SUBJECT: DRAFT FINAL TECHNICAL STUDY ON SPENT FUEL POOL ACCIDENT  
RISKS AT DECOMMISSIONING NUCLEAR POWER PLANTS

**DRAFT FOR COMMENT**  
**Draft Final Technical Study of Spent Fuel Pool Accident Risk  
at Decommissioning Nuclear Power Plants**

**February 2000**  
DRAFT FOR COMMENT

Figure 3.1 Assumed Spent Fuel Pool Cooling System

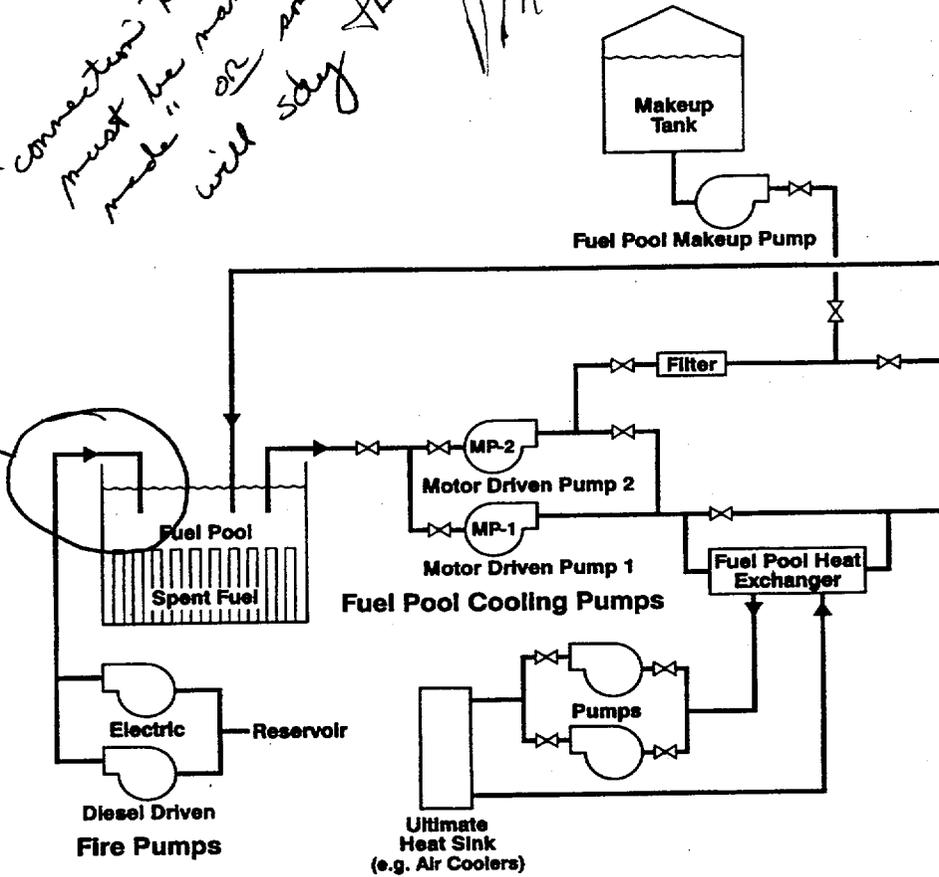
*Not sure if this is correct*

*We should state that staff recognizes the plants may have significantly more capability (eg emergency generator also M4 and CY) but for purposes of establishing a baseline for generic releasing, they were not considered*

*Indicate "connection to pool must be manually made" or one people will say this is misleading*
